Re: Proposed Acceptance Criteria AC398-0608-R2

Attachment A – Comments on AC398-0608-R2

RE: Proposed Acceptance Criteria for Cast-in-place Cold-formed Steel Connectors in Concrete for Light-frame Construction, Subject AC 398-508-R2

Figure 4

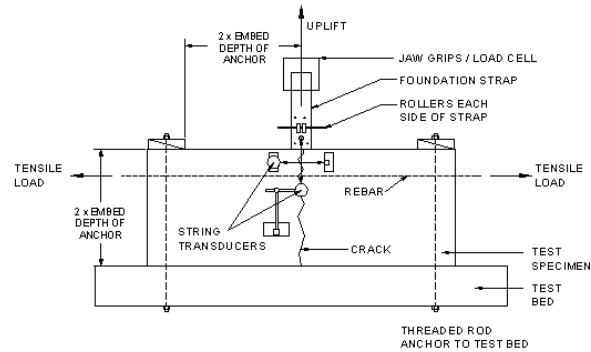
Figures 1-4: The following figures should be used instead of graphics from a specific manufacturer’s catalog. If this is not agreeable, it would be better to remove the figures and their references completely.
